# SANDY CITY COMMUNITY DEVELOPMENT

## Staff Report Memorandum November 16, 2023

To: Planning Commission  
From: Community Development Department  
Subject: Woodhaven Estates –  
Preliminary Subdivision and Site Plan Review  
7613 S. 300 E.  
(Community #3, Sandy Woods)

SUB01182023-006471  
SPR01102023-006464  
SPX110820023-006652  
PUD (12)  
2.03 Acres

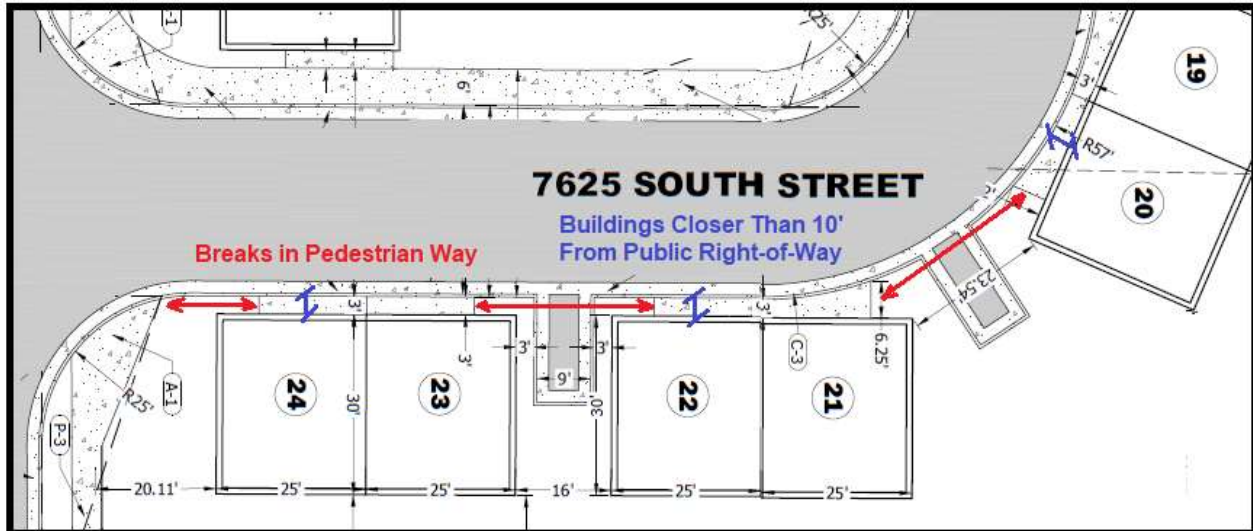
The applicant is proposing the elimination of sidewalks on one side of the street and parkstrips on both sides. The proposal is for the creation of a 38 foot public street which includes a 6 foot adjacent sidewalk, 2-1/2 feet of curb and gutter on either side, and 27 feet of asphalt.

**Road Design and Pedestrian Paths.** The applicant is seeking multiple exceptions and waivers for the proposed internal road design. The omission of sidewalks on one side and both parkstrips along the proposed street is not necessary to efficiently develop the property, nor does it further the objectives of the PUD. There are other design options available that would not require these omissions and would make the project more amenable to pedestrians. The applicant is seeking too many exceptions for road design which are in direct conflict with the purposes of the PUD Zone.

Preliminary Plat

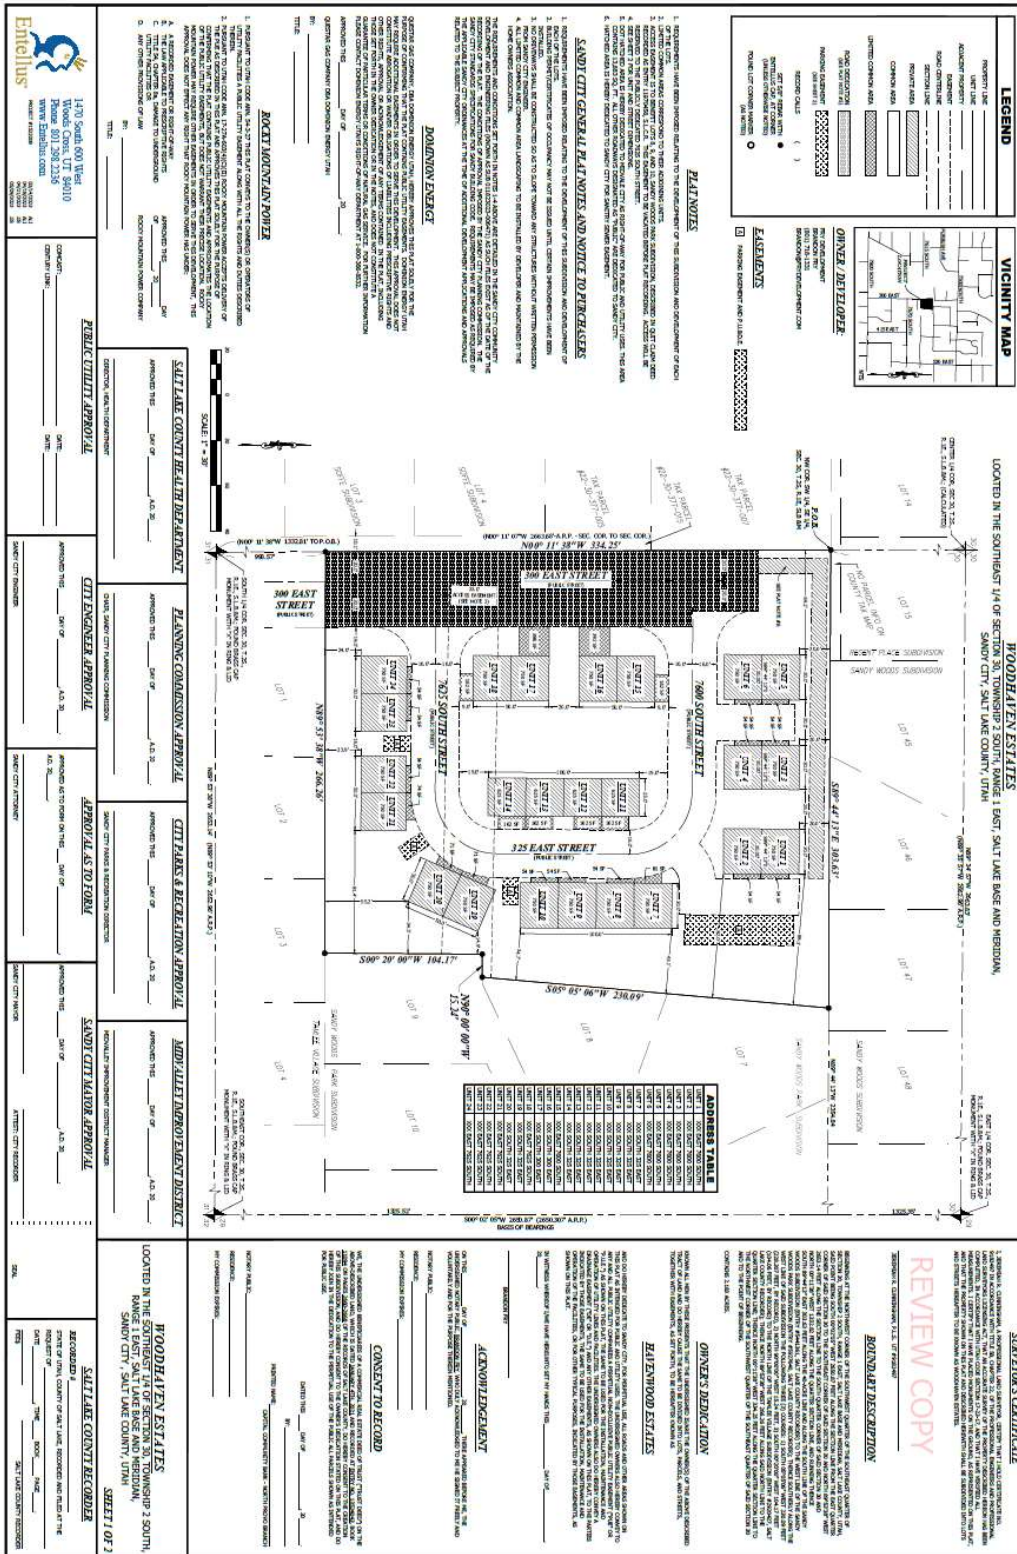
The applicant has shown the overall site area to be 2.18 acres and is proposing to develop 24 units, which is the maximum allowed by the zone for this size of area. However, that area includes portions of 300 East that has already been dedicated through improvement and use for several decades. The PUD zone density does apply to the gross acreage of a development but would not include existing roadways that have already been developed, improved, and dedicated as those would no longer be part of the developable parcels. This appears to drop the overall acreage of the development below 2 acres which would mean that the highest number of units allowed would be 23 under the PUD(12) designation. Further investigation and survey review will be required to determine the amount of gross land area that is not part of the existing roadways.

The proposed subdivision plat would create private ownership of each of the units, with limited common areas for private driveways, and common areas for all other open space areas. It would also formally dedicate to the public the existing 300 East Street, while also expanding the improvements and dedication to a full 60' width that matches the existing road profile. It would also dedicate the U shaped street that runs through the development at a width of 38'. A set of covenants, conditions, and restrictions have not yet been provided, but will need to be established to provide a means to manage the areas of common maintenance amongst the various owners.

**Unit Footprints.** Staff is also concerned that the preliminary plat and site plan does not appear to include cantilevered portions of homes that must be included in the footprint of the private lots. As no dimensioned building plans have been provided, it is unclear how far these projections extend. Currently, the plan shows the face of several structures three feet from the street for many units. While staff supports the varied look of these buildings by having cantilevered elements, those do apply to building setbacks.

2. That all city provisions, codes, and ordinances are adhered to during the review, construction, and operations process of this project.
3. That the existing private easement that provides access to lots 8, 9, 10 of the Sandy Woods Subdivision be vacated.

5. All structures and improvements for individual homes are to be restricted to the platted pad site, including but not limited to pop-outs, chimneys, porches, patios, decks, stairways, etc., and may not be built in the common areas.

6. That the setbacks for the subdivision be determined by the Planning Commission and that these setbacks be recorded as a note on the plat.
7. That the existing structures on the lots be demolished prior to recording of the subdivision plat.

### Site Plan

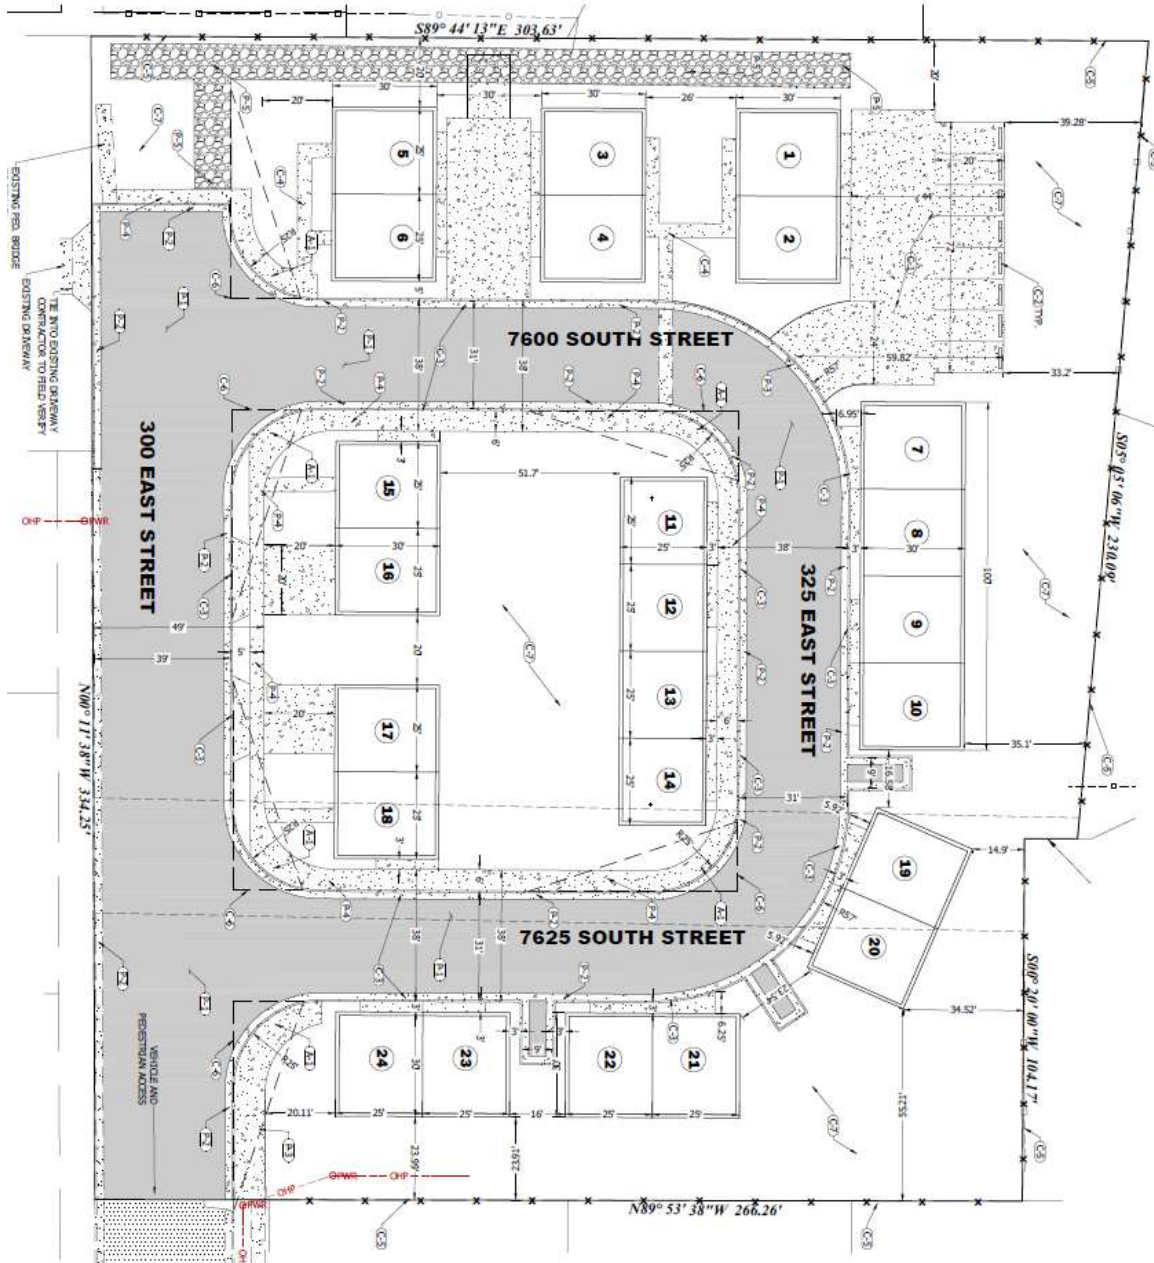
The proposed development is for 24 residential units consisting of duplexes and fourplexes along a U-shaped public street. The units are placed in a manner that allows for an appropriate layout that respects the existing land uses. The applicant has setback the units to be similar to the surrounding zones, with similar massing and scale. Where dissimilar uses are proposed, an increased setback that doubles the minimum setback of the adjacent zone has been accomplished. The buildings are proposed to be set very close to the internal public street, being setback as close as three feet.

All units include a 2-car garage with some units having a full driveway for guest parking. Eighteen of the twenty-four units are not provided with a full driveway depth and will have shared guest parking to provide the site with sufficient off-street parking for a total of 11 stalls. Most units front the public street with a front facing garage, while others are side or rear loaded units. This does provide for a variety of layout and building design while using essentially the same unit.

**PUD Design Objectives.** Staff has concerns that the current proposal does not comply with the objectives of the PUD zone. While the minimum percentage of open space is provided, it is not designed in a manner that makes these areas the focal point of design, it is mostly made up of setback areas, nor does it provide for any programed amenity spaces. No continuous pathways have been provided as the proposed public street disrupts pedestrian circulation with not enough infrastructure to support safe pedestrian circulation.

**Setbacks.** While the Planning Commission has broad authority to establish appropriate setbacks (especially those internal to the development), there are certain standards that the code requires. Buildings within a PUD are required to be at least 10 feet from a public street. This space is to be reserved for street trees and landscaping features. Many of the residential structures proposed do not meet this requirement, with front doors 3 feet from the public right-of-way.

**Existing Private Easement .** There is an existing private road that services the existing homes on the subject property and 2 lots in the adjacent subdivision. While the existing homes in the development will be demolished, the homes outside of the development will remain. The applicant proposes to eliminate this access. To do so, those adjacent lot owners will need to agree to the vacation of this easement and have access improvements made to Sandy Park Circle including removal of existing non-conforming fencing, creation of drive approaches and driveways.

2. That the existing private easement that provides access to lots 8, 9, 10 of the Sandy Woods Subdivision be vacated. Said lots shall be provided with driveways and drive approaches onto Sandy Park Circle as agreed to by the individual lot owners. The existing 6 foot fence along the circle shall also be removed to allow for this access and conform with front yard requirements. These proposed offsite improvements shall be shown and made part of the final site plan set.

3. That all city provisions, codes, and ordinances are adhered to during the review, construction, and operations process of this project.
4. All pad site areas be revised to accurately reflect all cantilevers, chimneys, porches, patios, decks, etc.

6. That the applicant works with staff to amend the layout and configuration of the development to better align and comply with the purpose, design objectives, and setback requirements of the Planned Unit Development code. If there is a significant change in layout and configuration of the development that it be required to come back to the Planning Commission for approval.

# Landscaping Plan

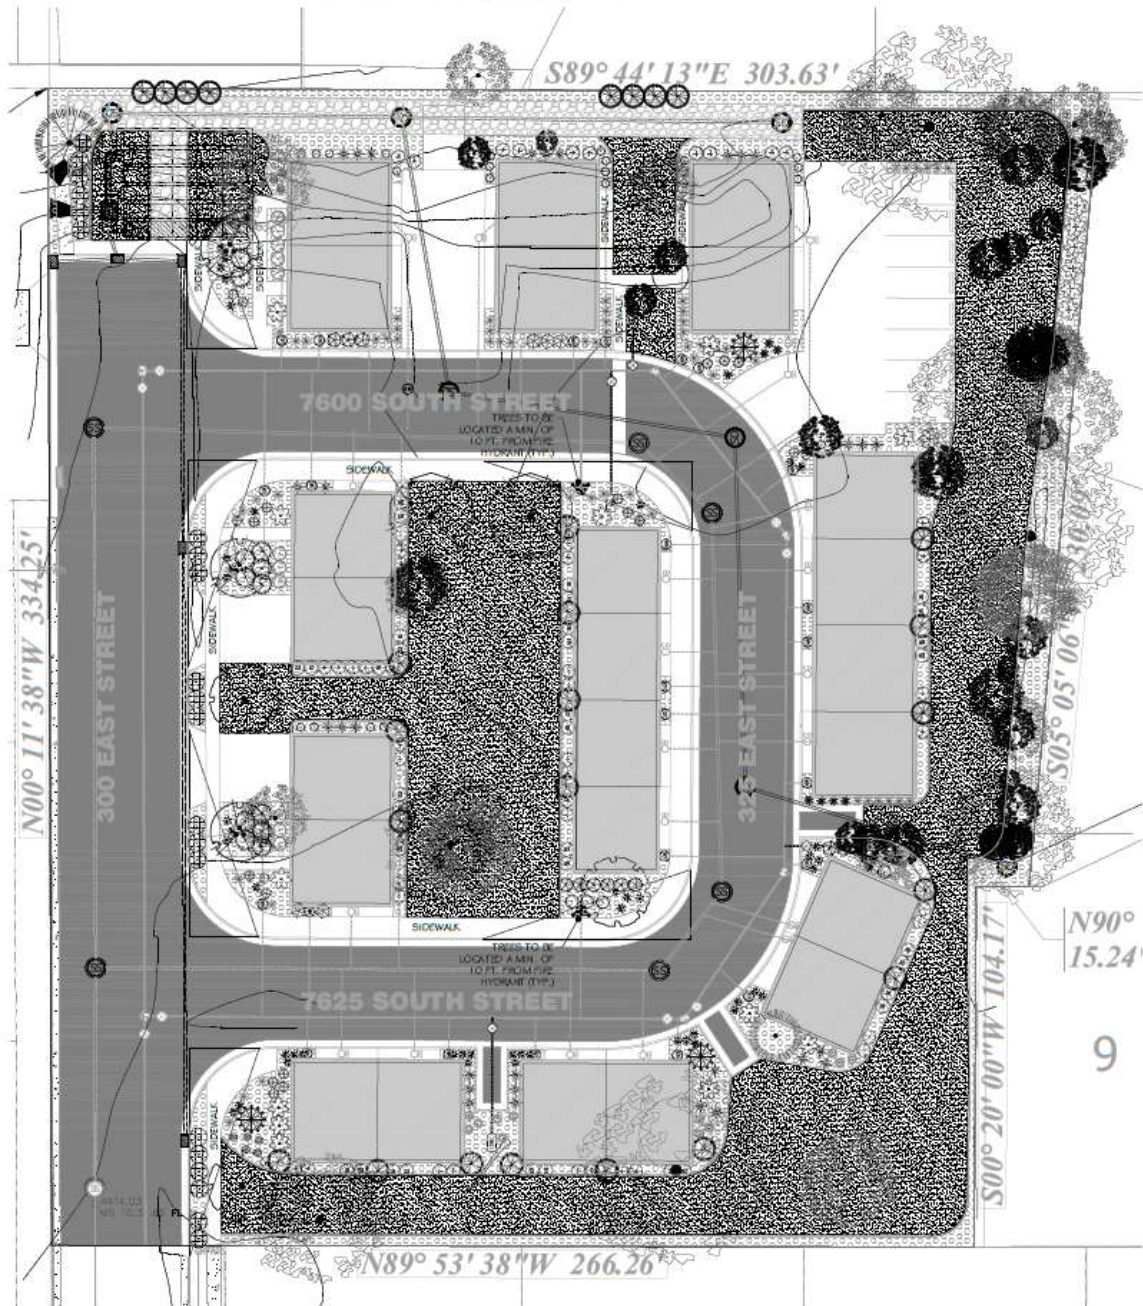
Open space is an important aspect of PUDs as it is used both for recreation and aesthetics in a higher density development. The PUD zone requires a minimum of 40% open space. This is calculated based on a combination of common (which is open to everyone in the subdivision) or limited common (which is not privately owned land but is limited to select users). Examples of limited common area can include patios or small backyards. The proposed project has precisely 40% of the land area being used as open space. A landscape plan has been provided and generally meets city requirements. The plans include a vinyl fence around the perimeter of the development. Open space that has been provided is primarily setback areas and one centrally located space which is the open rear yard areas of the middle units. Additional amenities may be required by the Planning Commission based on the size, scale, impacts, and nature of the development. This could mean that additional open space area above the 40% minimum or developing other amenities such as sport courts, playgrounds, etc.

**Amenities.** No specific amenities are proposed by the applicant, while meeting the minimum area requirements of 40%. Staff would suggest the creation of some usable open space amenity for the residents to enjoy, such as a playground, sports court, picnic table with gazebo, etc. The selection of an amenity should match the target demographic for the occupants of these units.

7. That the Planning Commission determine an appropriate amenity package for the application.

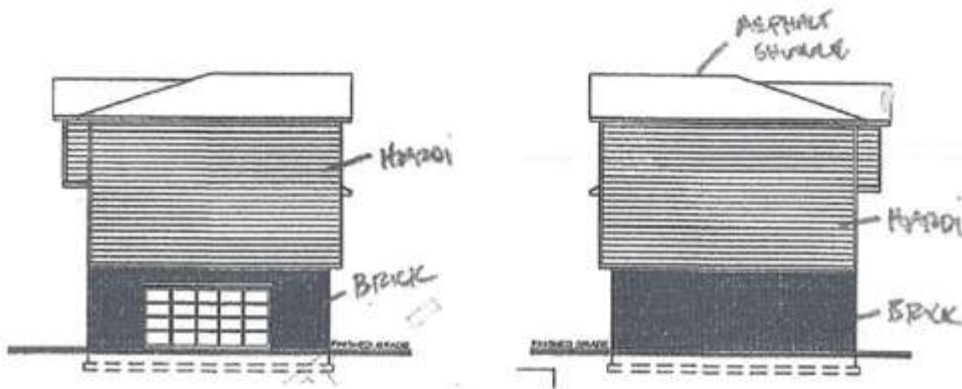
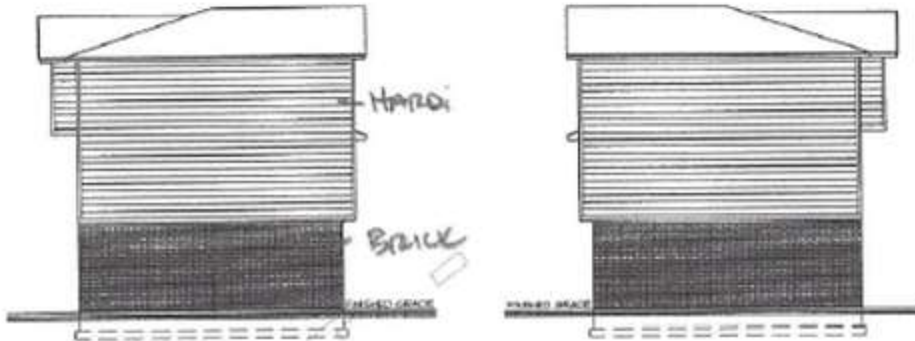
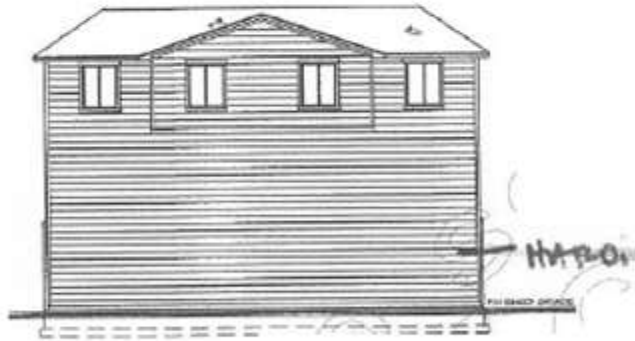
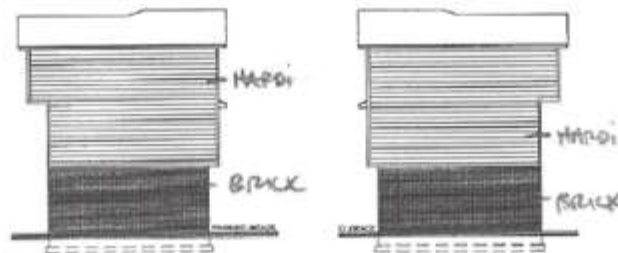
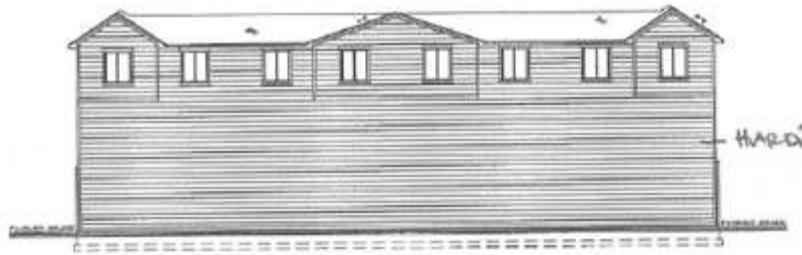
The buildings materials proposed by the applicant contain a combination of brick and various types of cement fiberboard. They have pitched roofs with asphalt shingles. The design contains multiple cantilevered elements that break up the façade

on certain elevations. While not dimensioned on the plans, the buildings will need to be under 35' to the peak of the roof to the average finished grade.

**Building Design.** The plans lack articulation on the sides and rear elevations with very little fenestration of doors and windows. Additional windows to the end units and the rear elevations would greatly improve the design. Covered front porch entrances would also improve the design of the front elevation and making the units more pedestrian friendly. Internal garages also need to be designed to have at least a 20' x 20' internal area to ensure they can accommodate two vehicles.

5. That the applicant works with staff to amend the architecture for the townhomes to address the concerns discussed in this report. If any significant change to materials or design, be required to come back to the Planning Commission for approval.
